**Environmental
Planning
Commission**

Staff Report

Agenda Item Number: 2
Project #: PR-2023-009363
**Case #: SI-2023-01635/
SI-2023-01638**
Hearing Date: November 16, 2023

Agent	Consensus Planning
Applicant	City of Albuquerque Parks and Recreation Department/New Mexico United Soccer
Request	Major Amendment of a Master Development Plan/Site Plan for Subdivision Site Plan-EPC
Legal Description	All or a portion of Tracts A-1 through G-1, Plat of Tracts A-1 through H-1, I-1-A & I-2-A, Tract I-A-A, Plat of Tracts A-1 through H-1, I-1A & I-2-A, and a fraction of Lot 2, located in NE ¼ NE ¼ Sec 11, T11N, R3E, a/k/a Tracts F & G, Heirs of Filiberto Gurule Tract
Location	Balloon Fiesta, Park, between Paseo del Norte NE and Roy Avenue NE
Size	Approximately 7-acre portion of 367.5 acre site
Zoning	NR-PO-A

SHEET 11 OF 11
NOV. 05, 2023

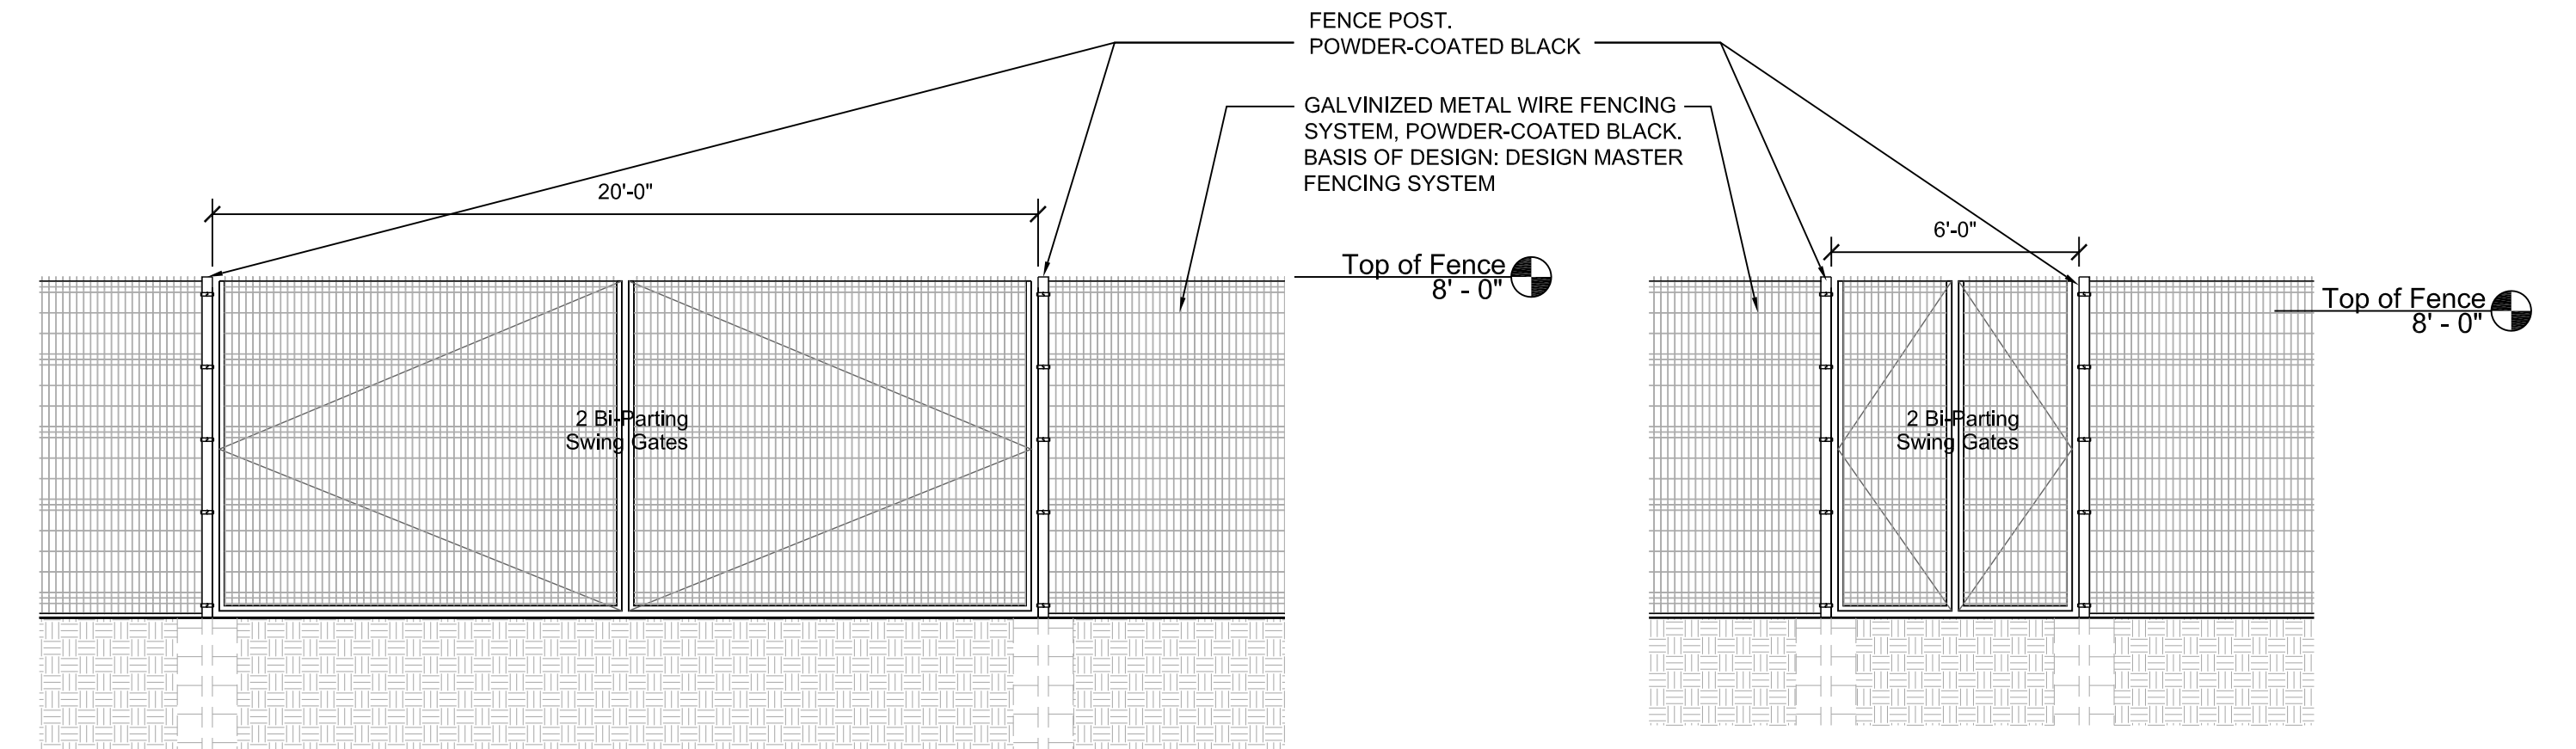
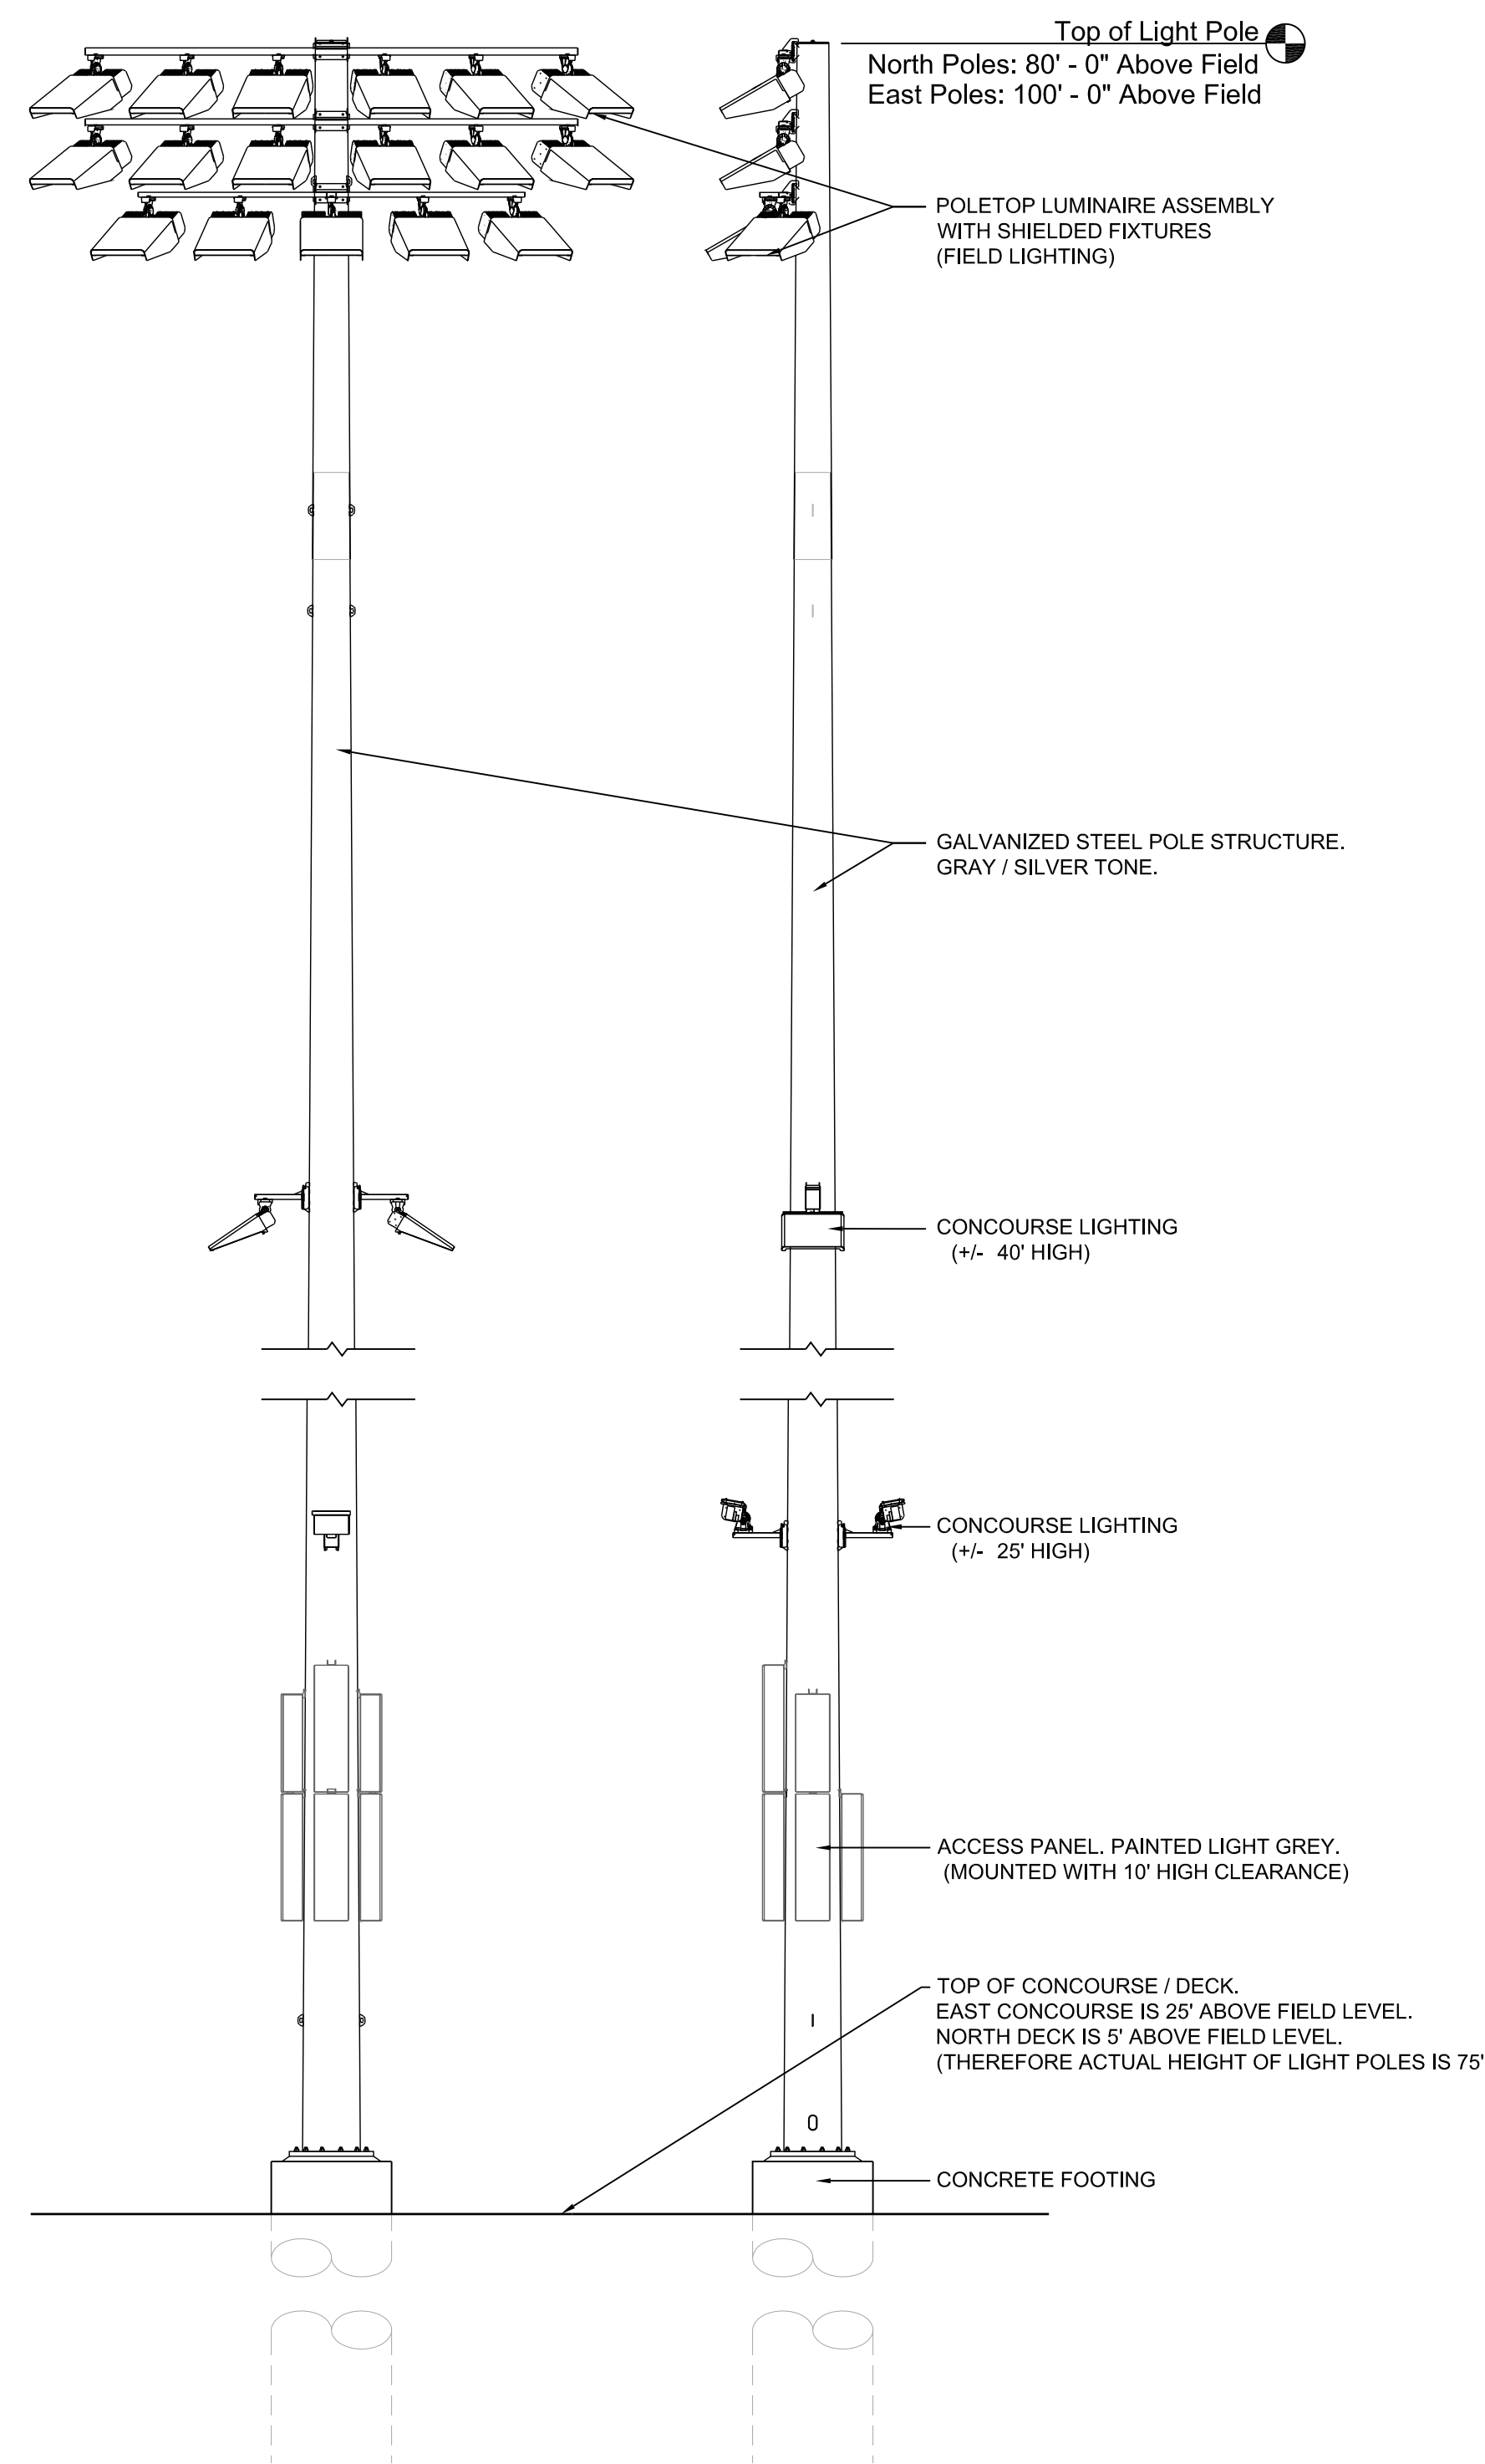
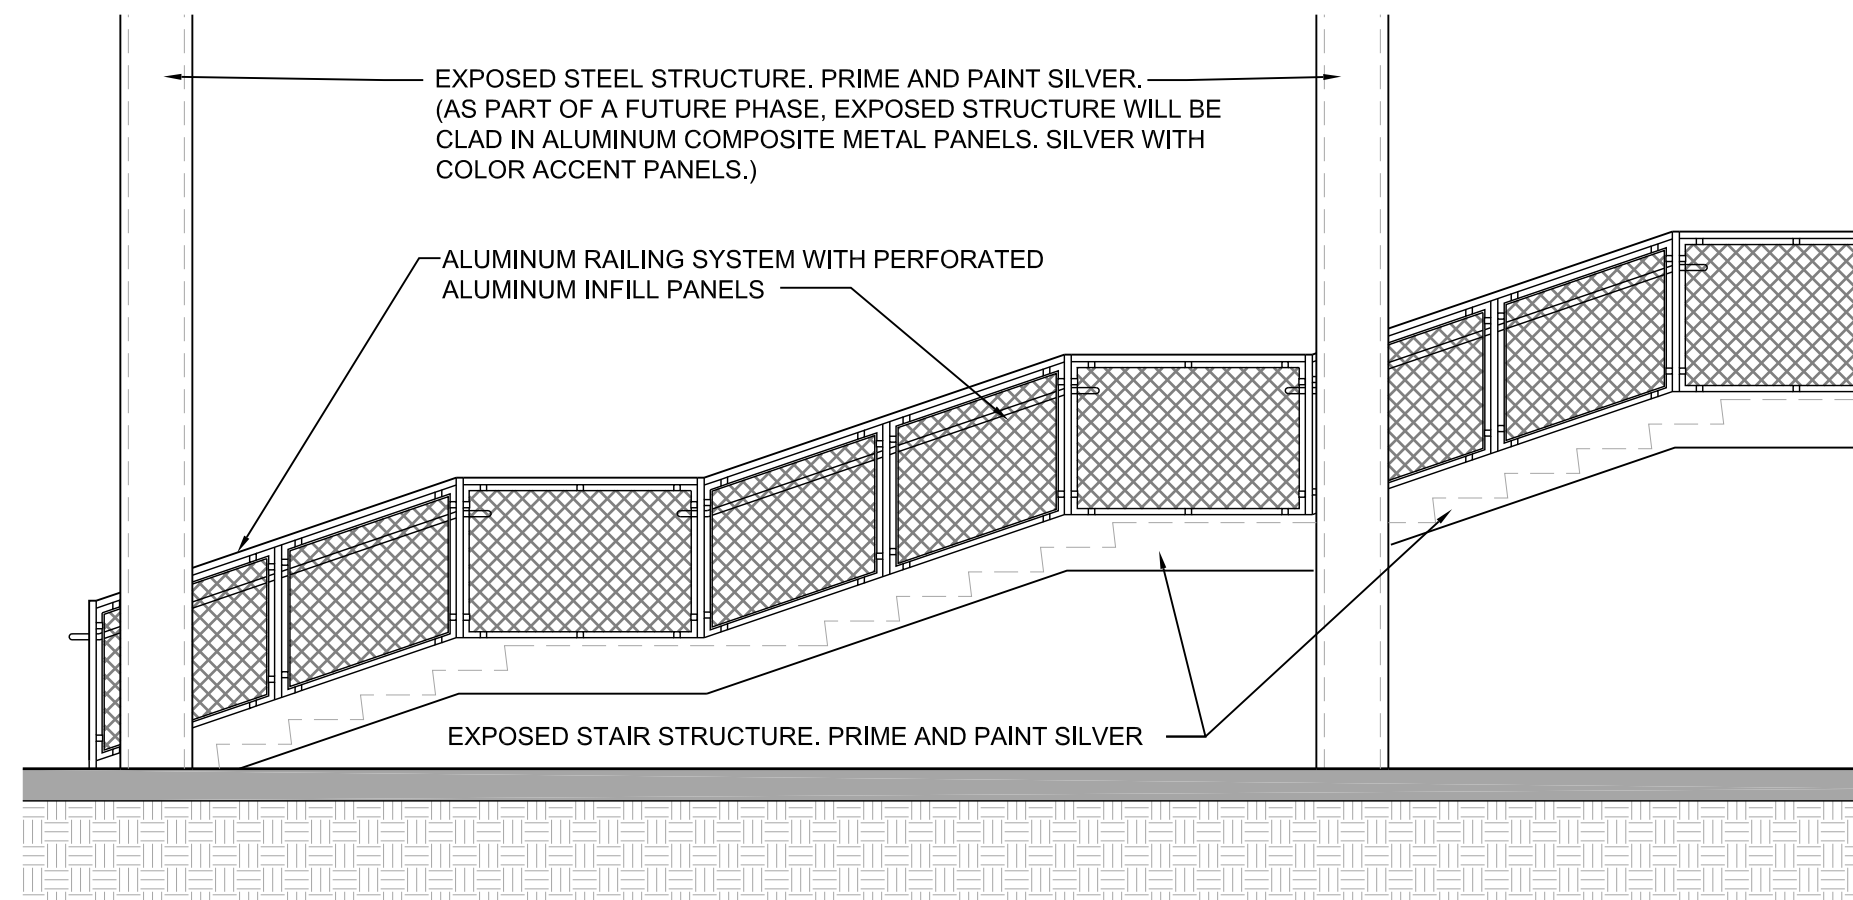
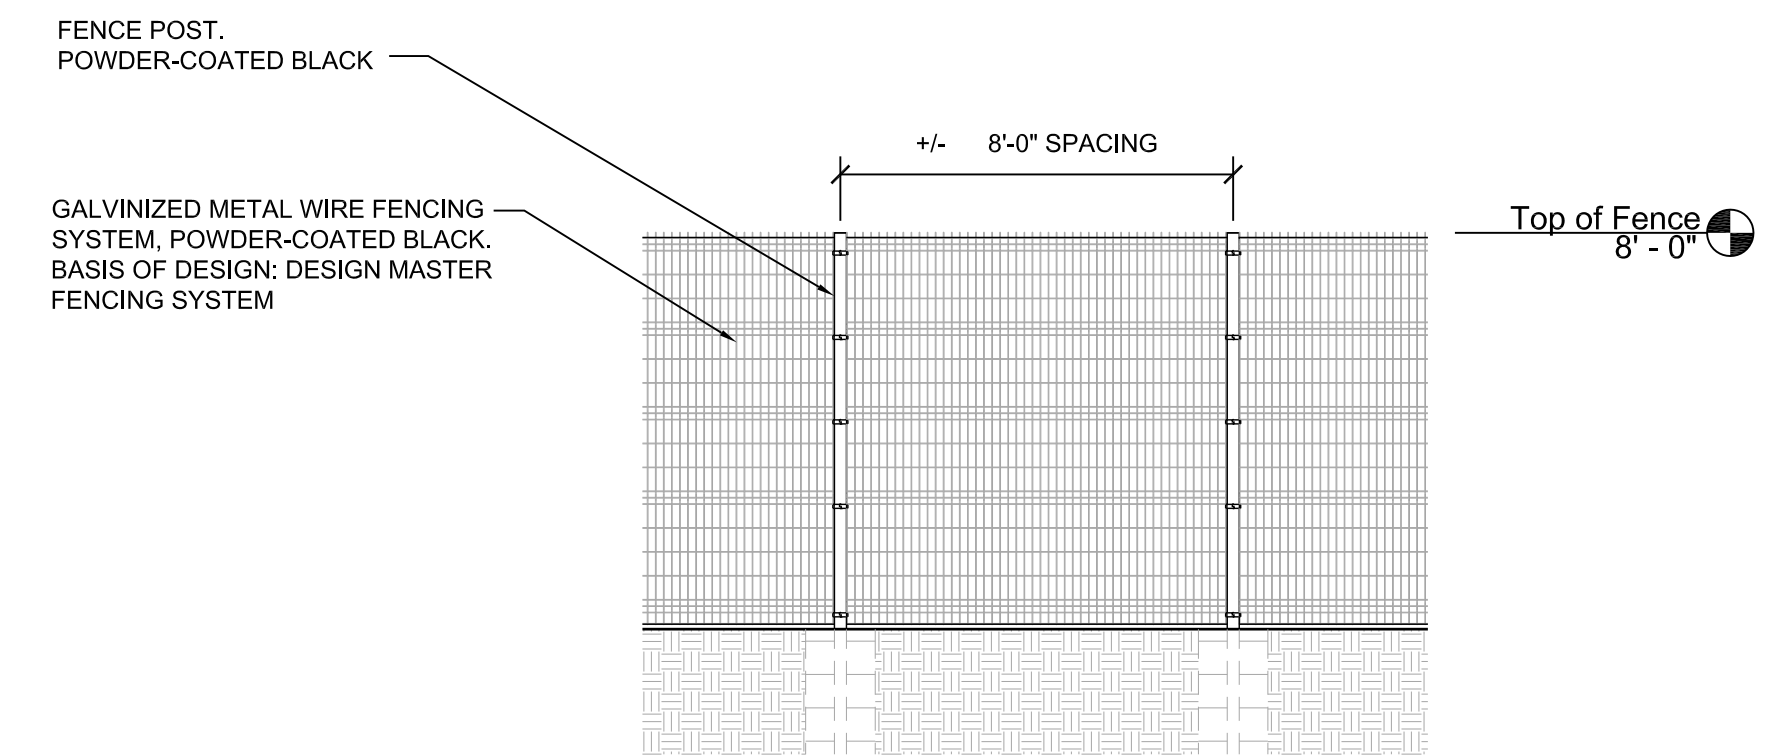
Sign #1, labeled “*New Mexico United*,” will consist of a 12-inch deep aluminum frame housing an LED-backlit translucent acrylic logo made from black and translucent yellow acrylic. The signs dimension will be 16’-6” x 13’-0” as detailed in Architectural Details on Sheet 11.

Sign #2, labeled “*Somos Unidos*,” will consist of LED-backlit die cut aluminum letters with an anodized aluminum finish as detailed in Architectural Details on Sheet 11.

Stadium lighting details have been provided (Architectural Details – Sheet 11). Upon approval of the MDP text amendments, the stadium lighting will be in compliance with MDP standards.

Bollard lighting will be installed that will be firmly secured in a concrete foundation. The bollards will be crafted from robust die-cast aluminum with an anodized finish. The LED light source will be protected by a transparent acrylic cover. Each bollard light will stand at a height of 3’-6” (Architectural Details – Sheet 11).
